**Project: South Battery Park City Resiliency Project:
Wagner Park Pavilion Construction Services
Request for Proposals (“RFP”)**

Date: May 5, 2022

RE: Addendum #11

A-113.00

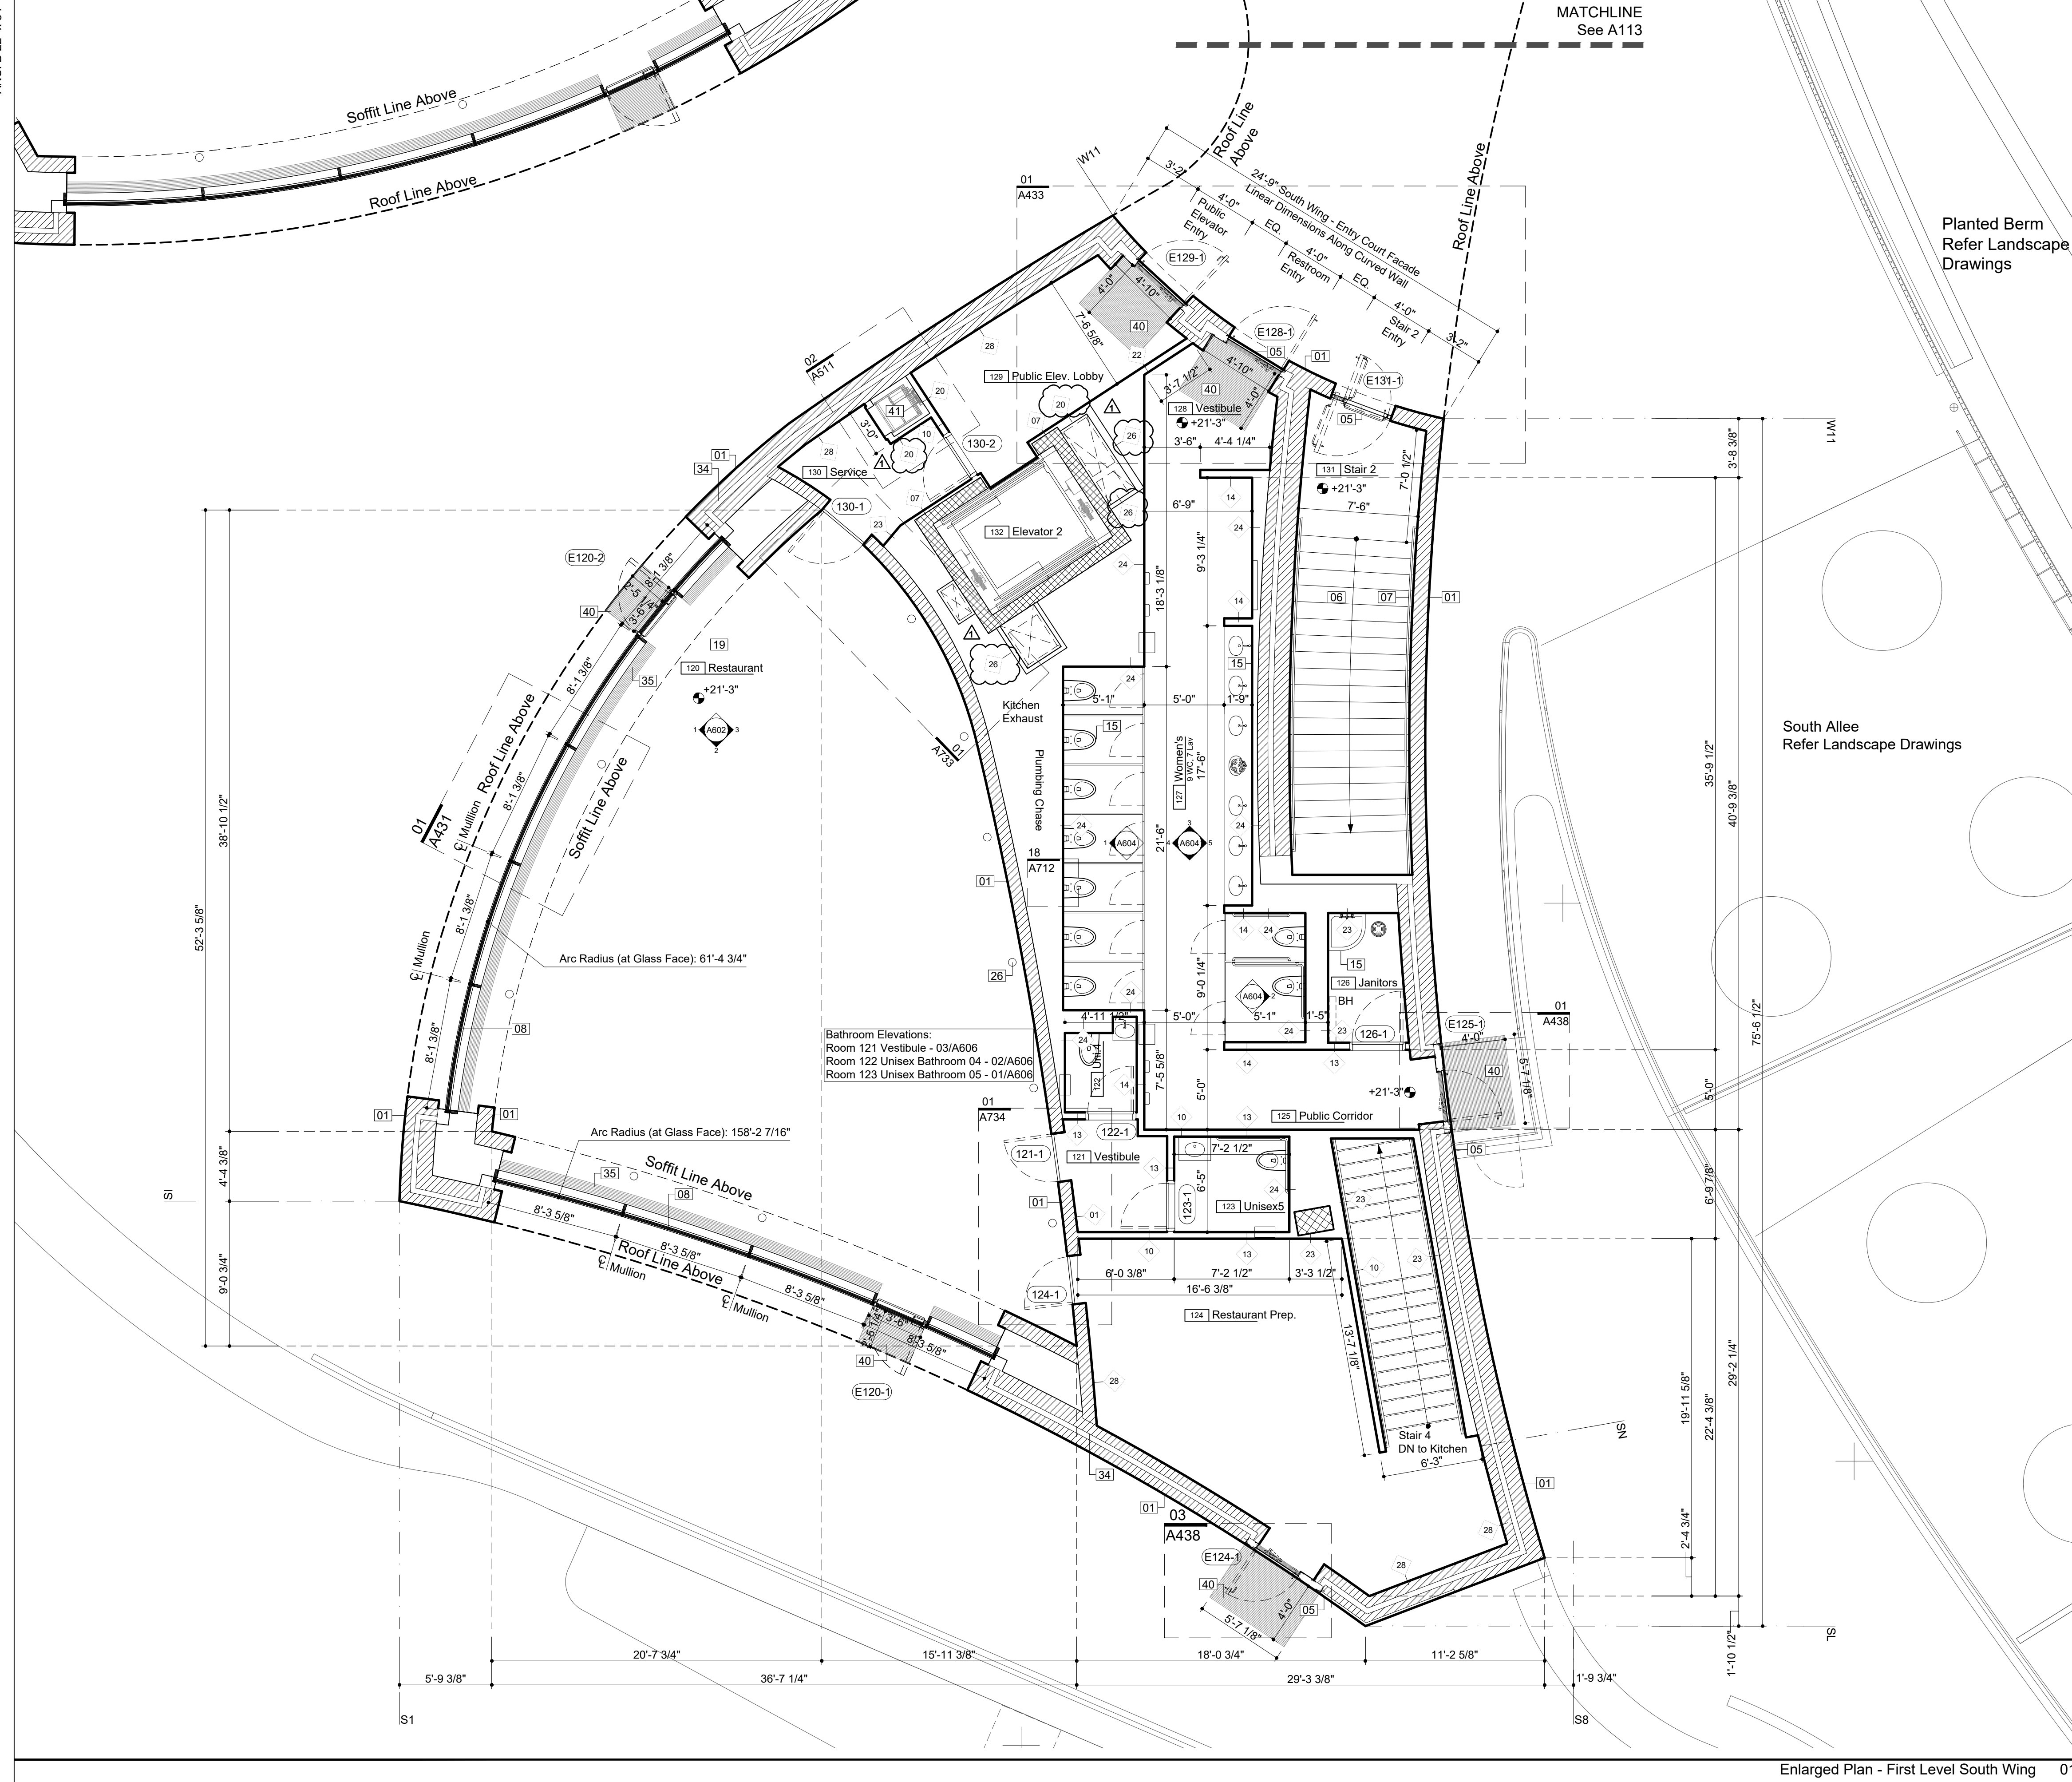
- 3) The detail for wall type 21 shows one layer of fire rated gypsum board. Page A-008 shows that wall to be a two hour fire rated partition. Please advise.

Wall Types have been revised in First and Second Level plans to reflect correct wall types. Refer to revised sheets A-113, A-114, A-116, and A-713 – which, as mentioned in Section A above, are attached hereto as Attachments #1-4, respectively.
